Safety Notice Technical Bulletin No. 019

No. 019	Target audience Affected users	Date 2020-04-09	Number of pages 5
Affected products Battery corpuls cpr P/N 09120	Serial numbers / Lot identification No relation	Software / Firmware Each firmware version up to and including 1.3-004

Illustration 1: Rating plate battery corpuls cpr - e.g. firmware version 1.2-002

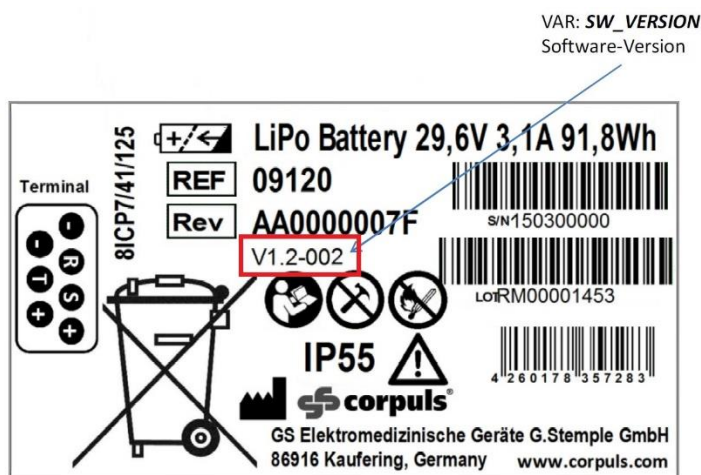
Your battery corpuls cpr has installed one of the firmware versions up to and including 1.3-004 that we have identified as problematic.

This can be seen on the rating plate of the battery corpuls cpr.

Maintenance for each battery will be promptly arranged. A new firmware version 1.4-000 or higher will be installed on your battery corpuls cpr by our authorised sales and service partners. So you will soon have a fully operational corpuls cpr.
